SOUTHEASTERN DISTRICT HEALTH DEPARTMENT  
INDIVIDUAL SEWAGE DISPOSAL INSTALLATION PERMIT

Permit No. \_\_\_\_\_ Date 4-78  
 Installation for Dennis Madden at T. 6, S. Range 34 E. B. M. 19 a.  
(Name) (Legal description of property)  
 Address of Installation Rt 1 Tank Farm Rd. Pocatello Idaho  
 No. Living Units 2 Bedrooms 4 People Served 4 Water Supply—Private  Public   
Total Total Applicant is: Owner  Contractor  Other   
 FHA  FARM HOME  VA  CONV.  EXISTING  NO.

Applicant's sketch of house, proposed sewage layout and all adjacent wells (dimension between all components)

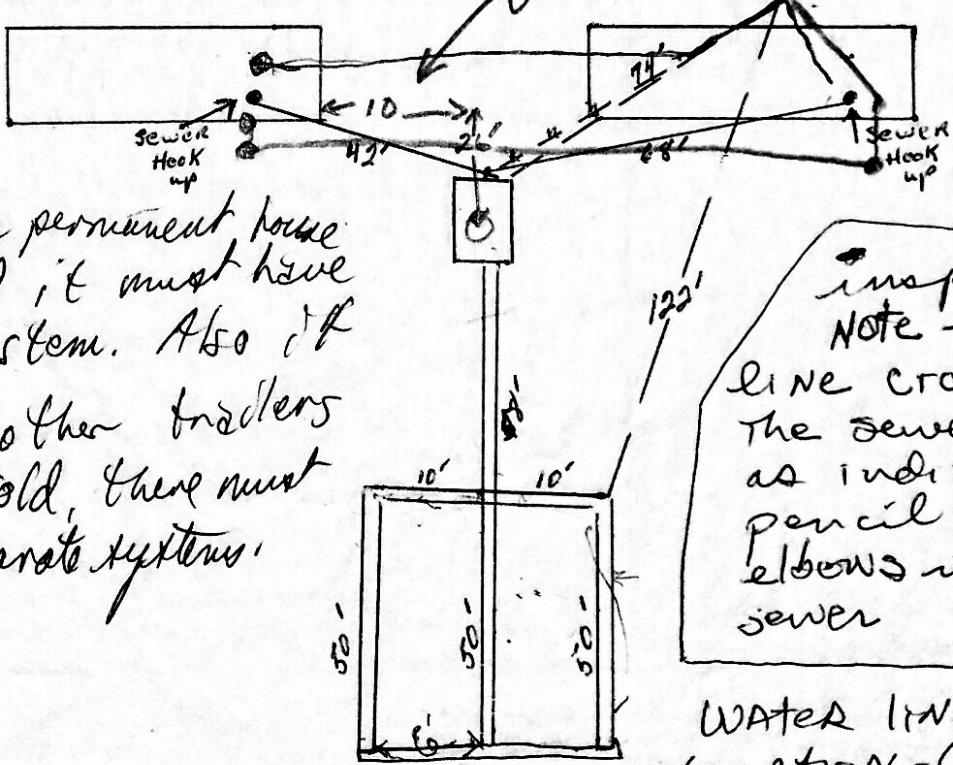
Approved \_\_\_\_\_ Not Approved  Inspected 4/11/78 by Ferguson Installed by Self  
(Date)  
 Remarks: sewer line above water line

Should a permanent house be constructed it must have its own system. Also if one or the other tractors or lots be sold, there must then be separate systems.

inspection.  
 NOTE - WATER LINE CROSSES UNDER THE SEWER LINE AS INDICATED IN PENCIL - THE ELBOWS IN THE BLDG SEWER

WATER LINE CHANGED LOCATION - (Red) TO ELIMINATE CROSS OVER
